Montgomery Planning | Countywide Planning and Policy Division

09/23/2021
 Agenda item 4

Montgomery Hills MD 97 Design Project

Mandatory Referral # MR2021033

Georgia Avenue – South of 16th Street

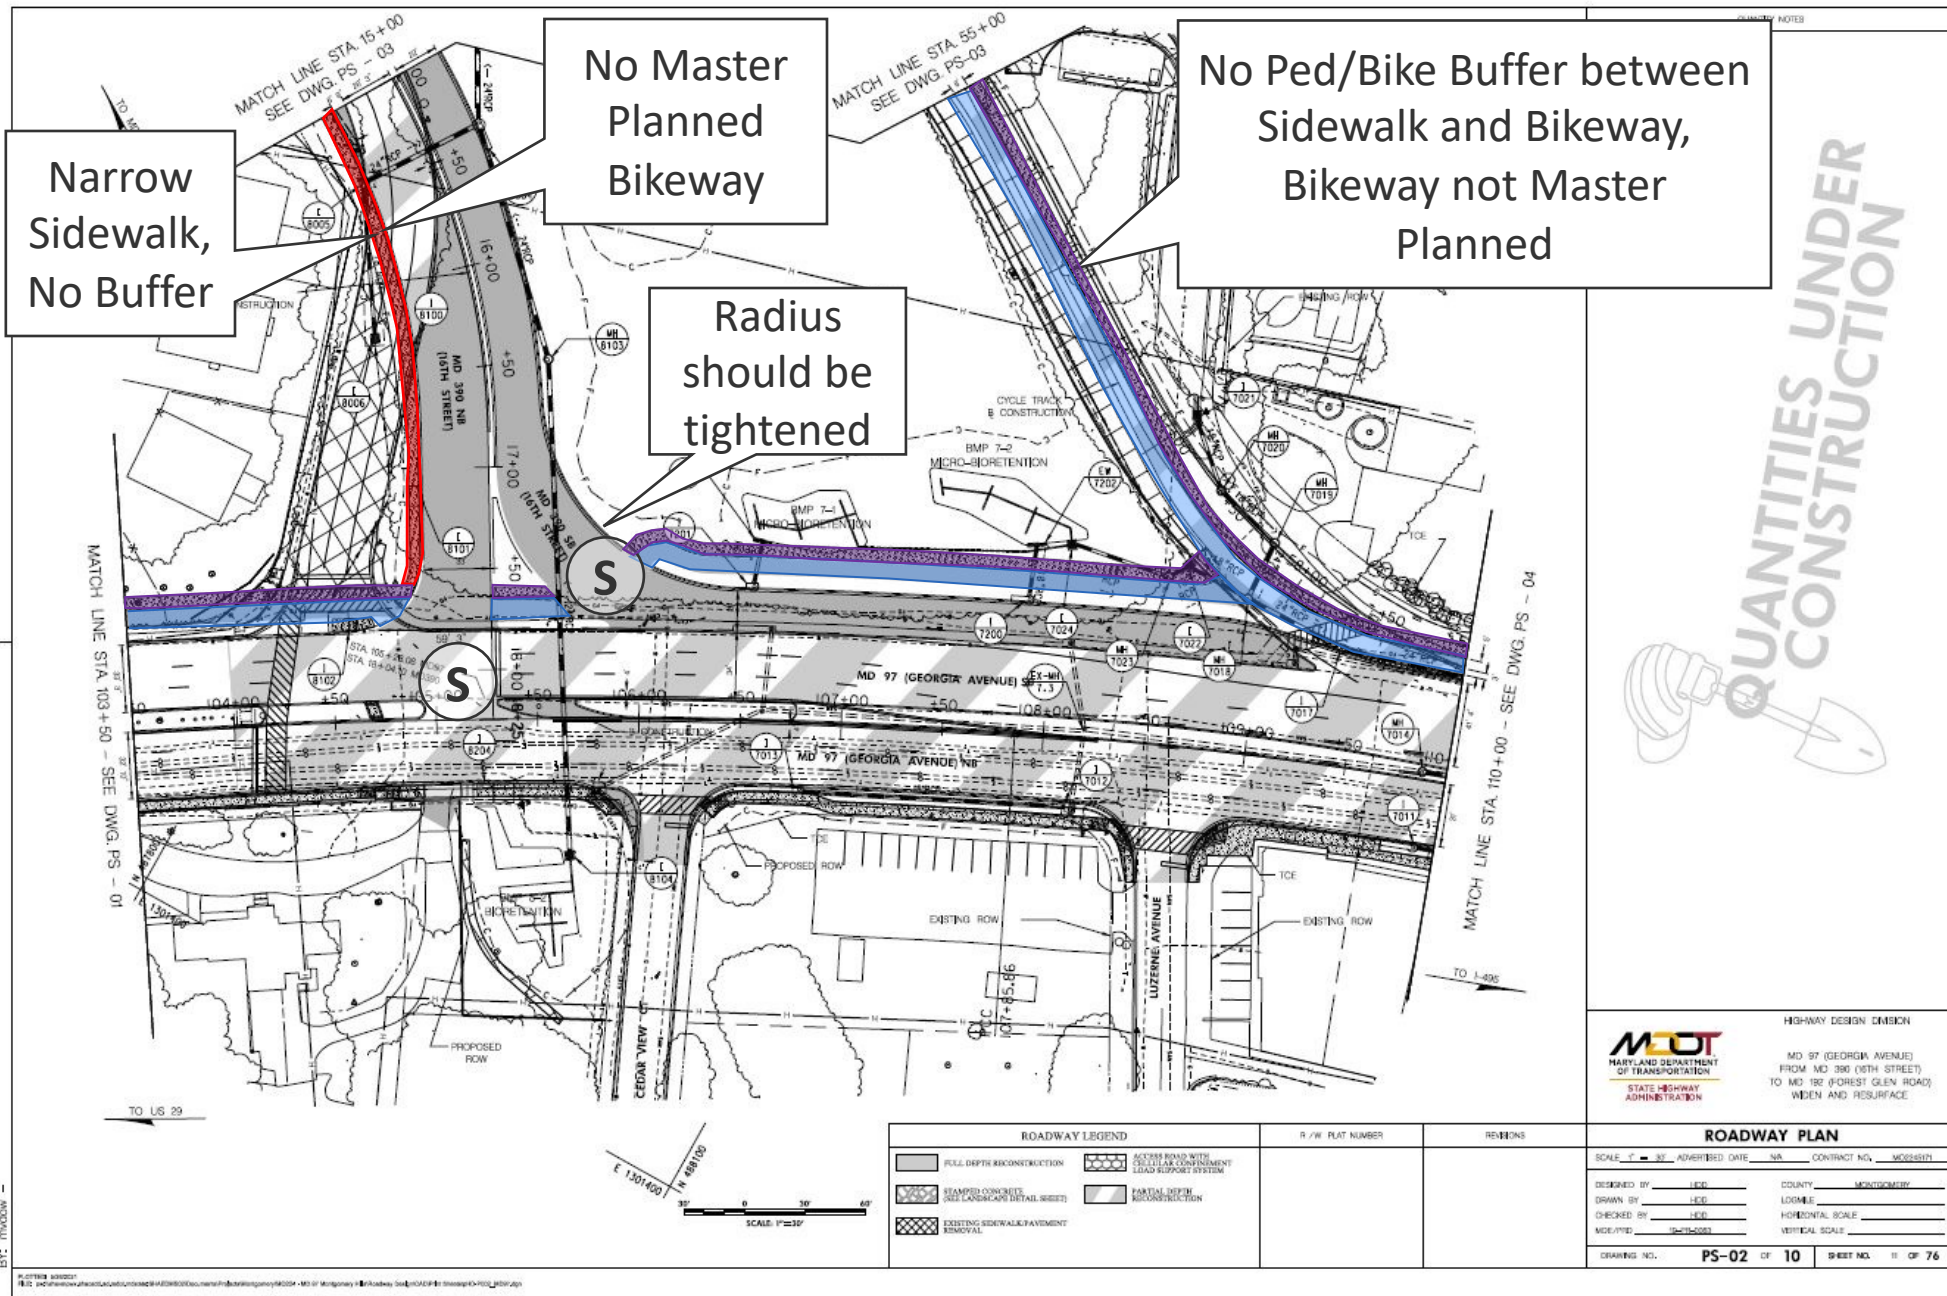
Separated Bike Lane not shown in current design

16th Street Cross Section west of Georgia Avenue

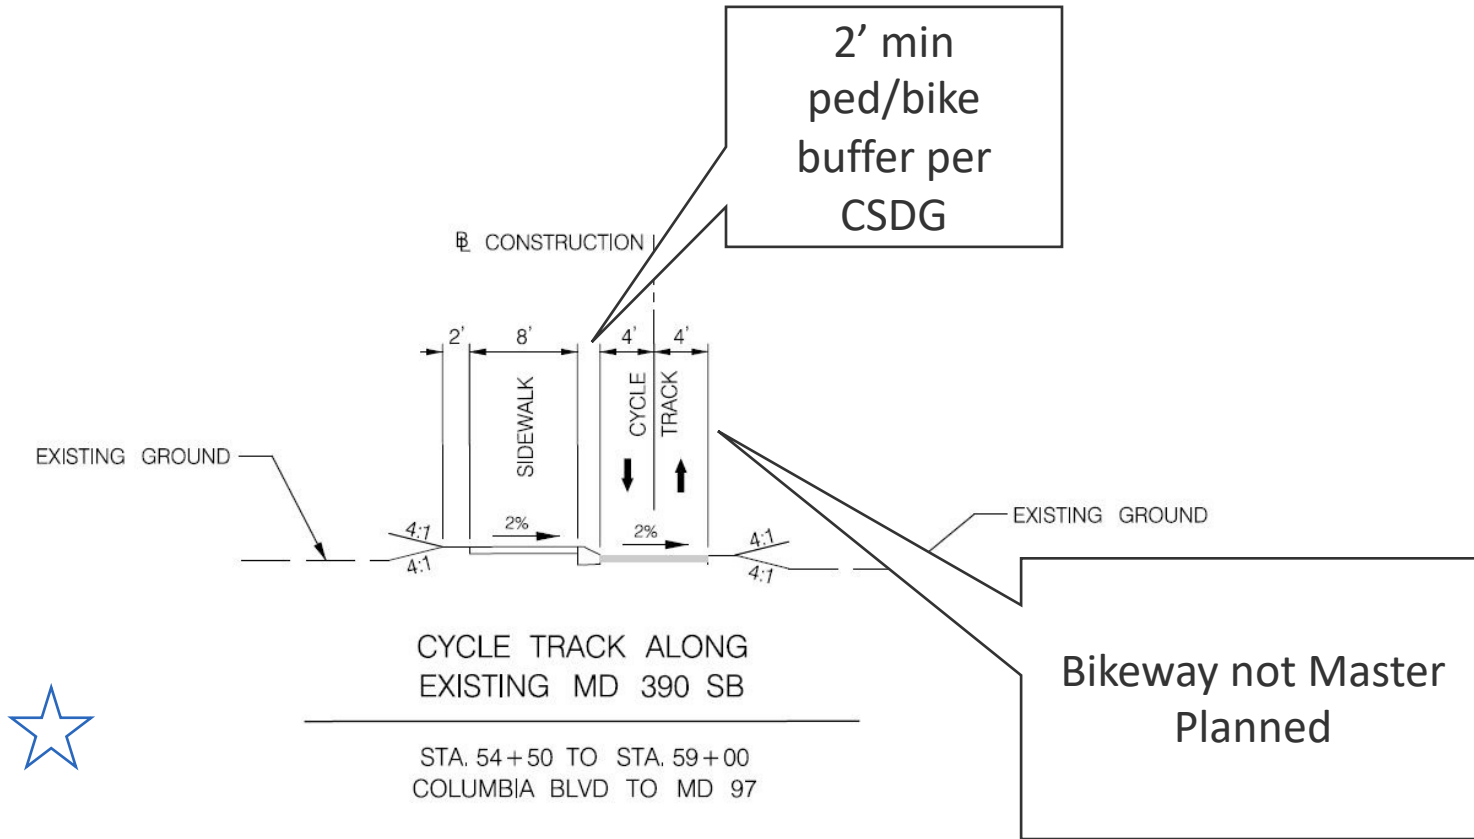
6' min buffer per BMP and CSDG

Master Planned Separated Bike Lanes not included

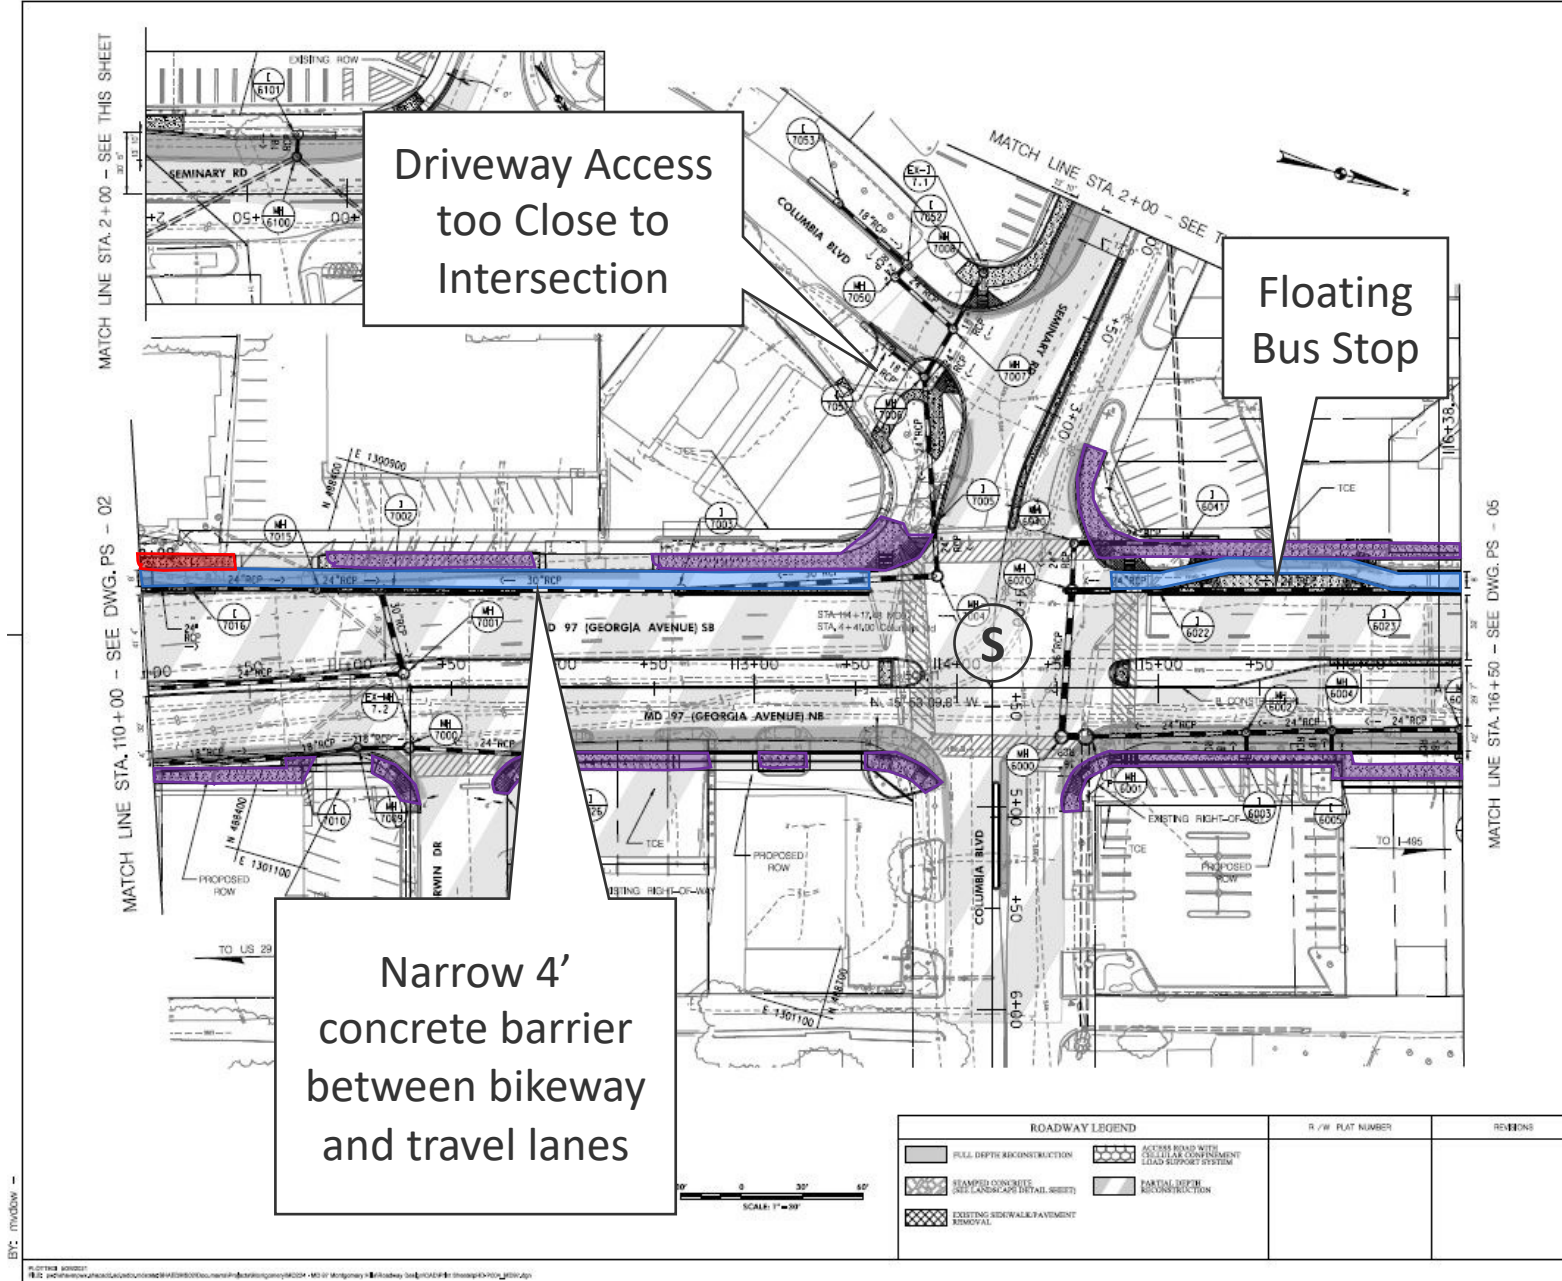
8. **The parcel located on the southwest quadrant of the MD 97/Seminary Road intersection has been designed with an extra access onto Columbia Boulevard. This driveway, as shown on plan PS-04, is too close to the intersection of Seminary Road with Columbia Boulevard, and this parcel already has one access point on Columbia Boulevard. This driveway should be removed from the design.**

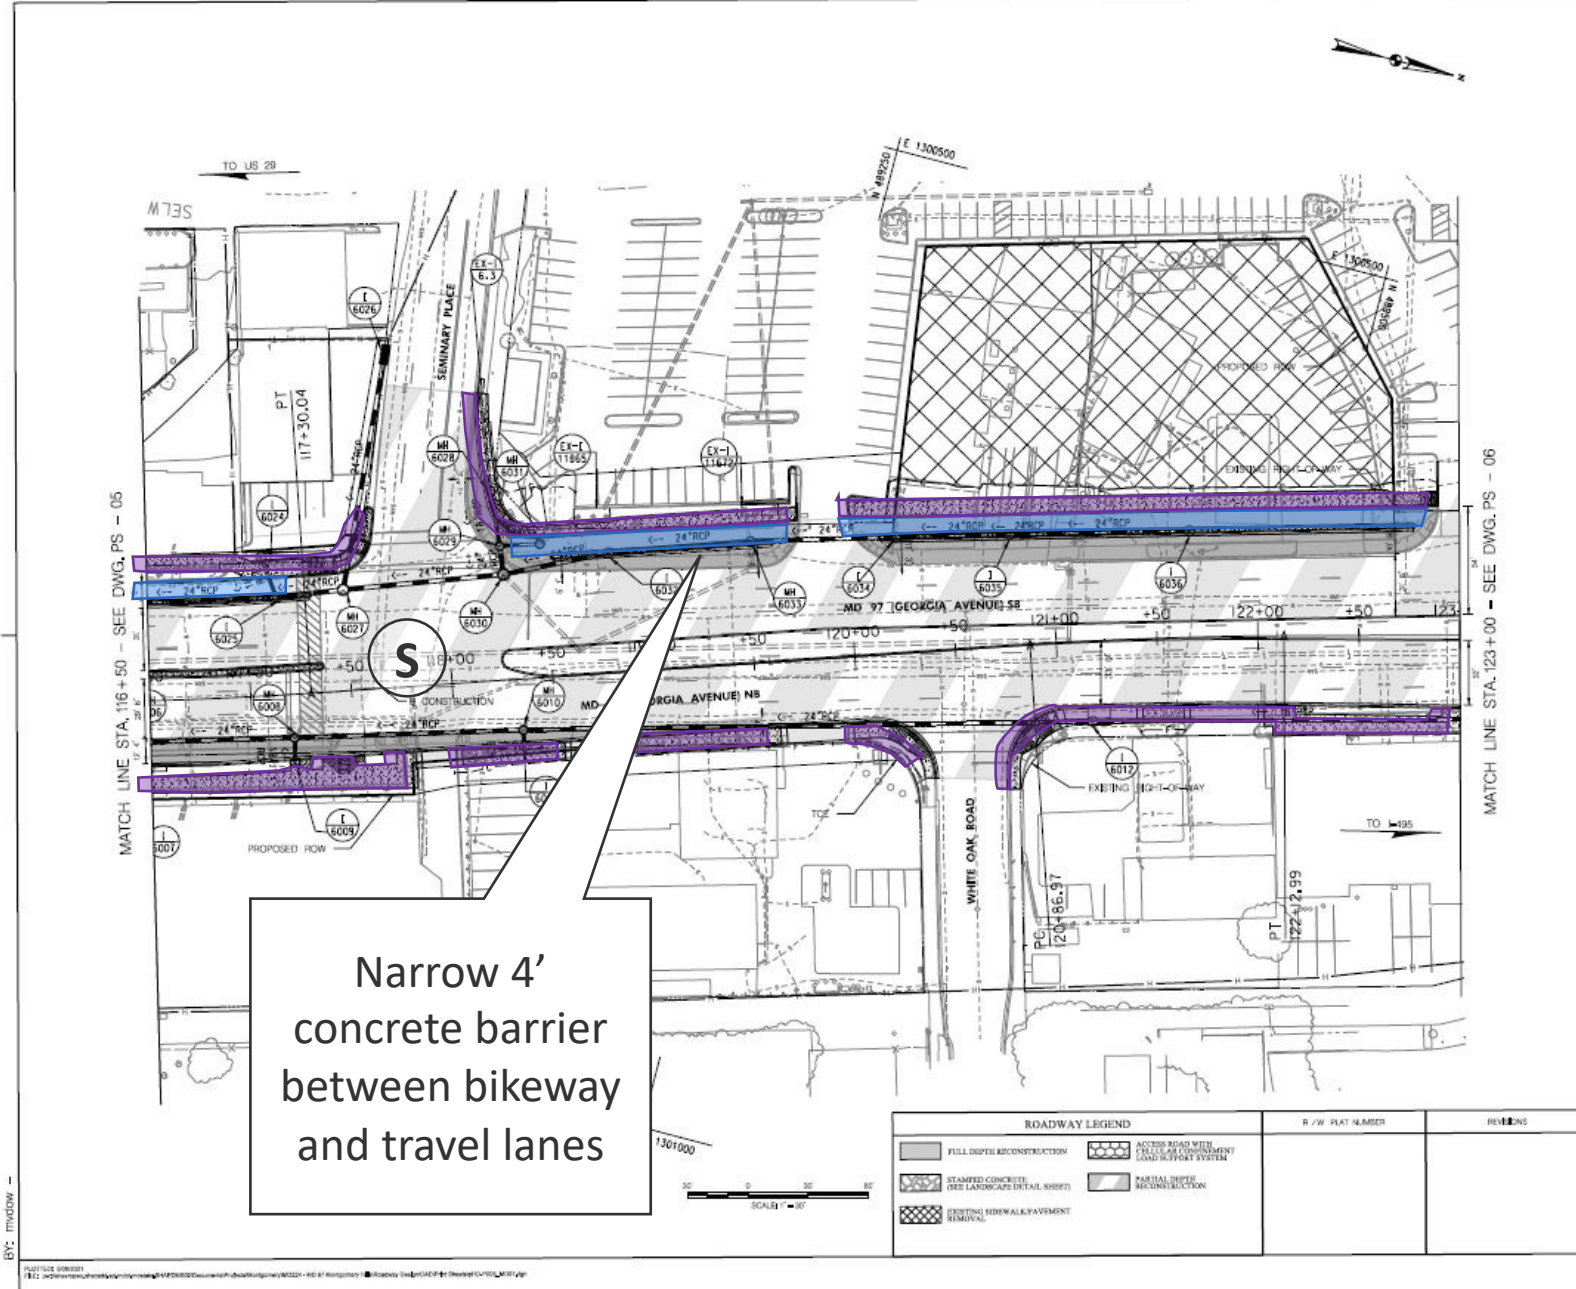
Narrow 4' concrete barrier between bikeway and travel lanes

ROADWAY PLAN
 SCALE: 1" = 40' ADVERTISED DATE: NA CONTRACT NO.: MDC025214
 DESIGNED BY: JEE COUNTY: MONTGOMERY
 DRAWN BY: JEE LOCAL: _____
 CHECKED BY: JEE HORIZONTAL SCALE: _____
 DATE: 10/15/2021 VERTICAL SCALE: _____
 DRAWING NO. **PS-08** OF **10** SHEET NO. **17** OF **76**

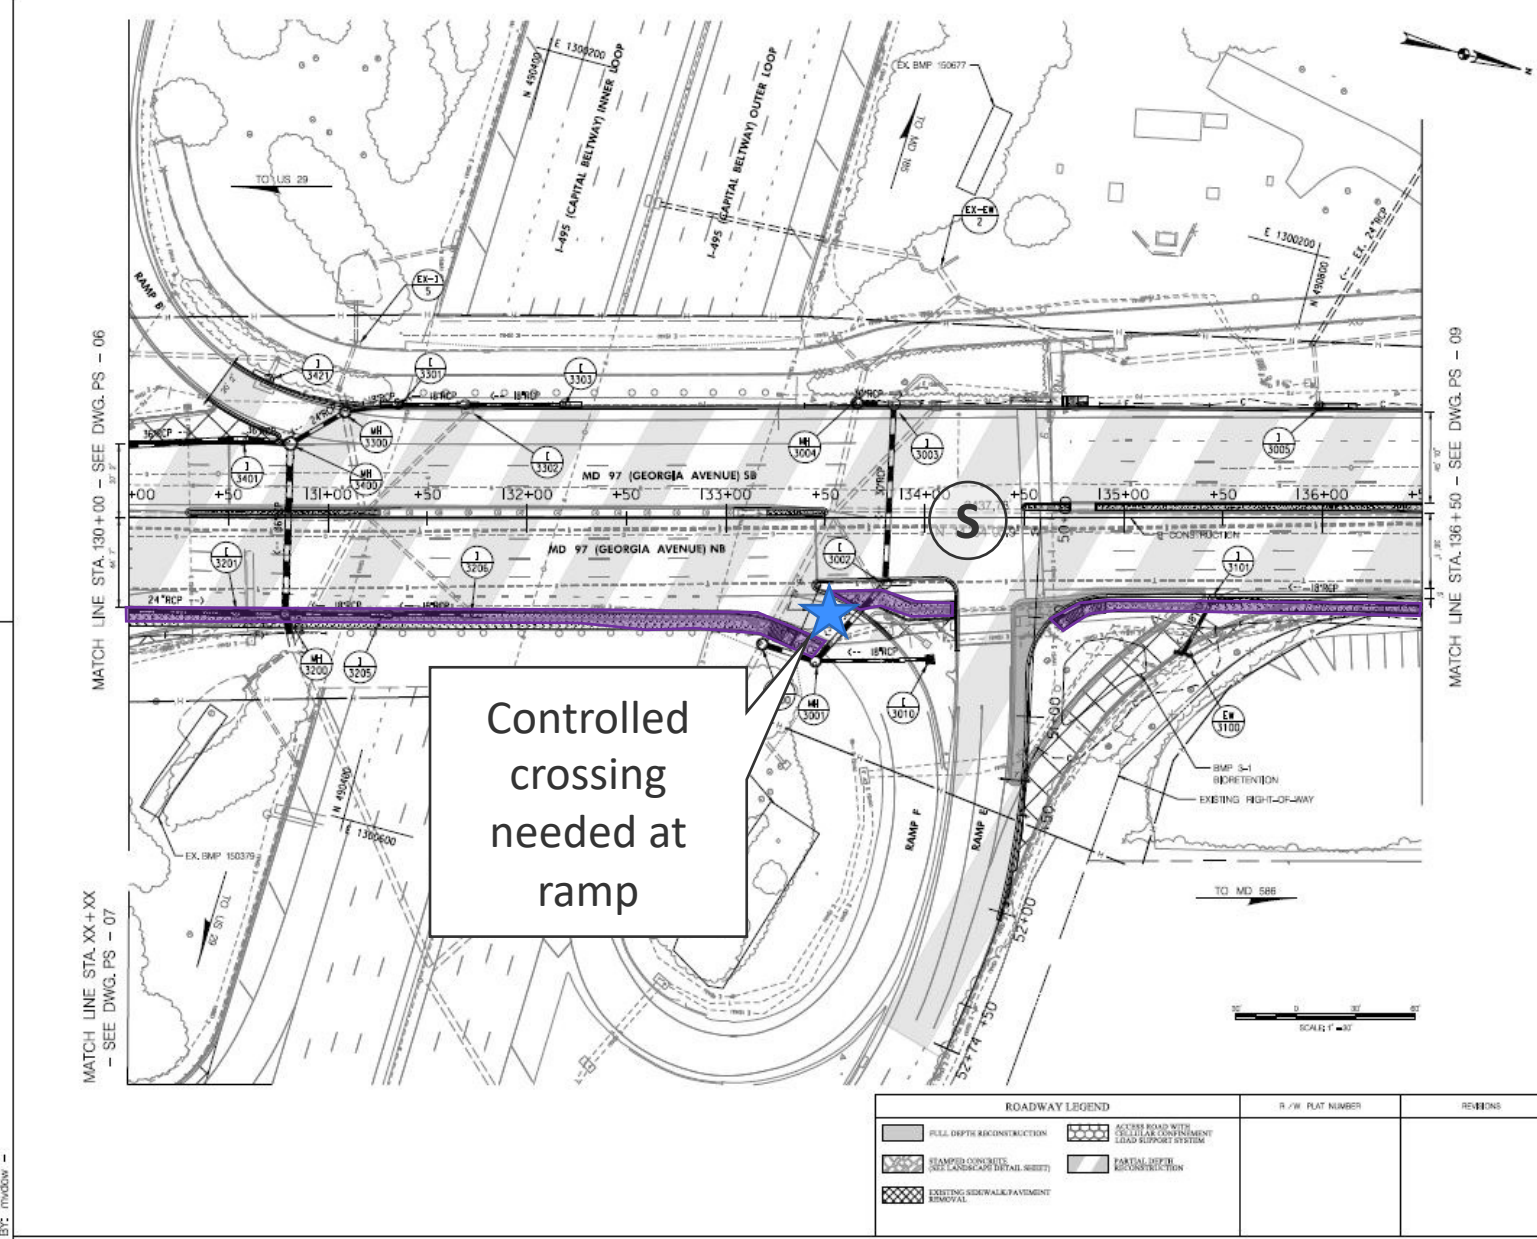
Controlled crossing needed at ramp

9. The two I-495 on-ramps from northbound MD 97 should have protected crossings (signals) for pedestrians and bicyclists.
10. Remove the island and tighten the turn radius at the intersection of MD 97 and Locust Grove Road.
11. Eliminate the median on Forest Glen Road east of Georgia Avenue and use the space to provide a buffer between the sidewalks and the street.
12. Bike signals should be included in the design for the separated bike lanes.
13. Protected intersections are needed to improve safety for pedestrians and bicyclists where the separated bike lanes and sidepaths intersect with Seminary Place, Seminary Lane and 16th Street.
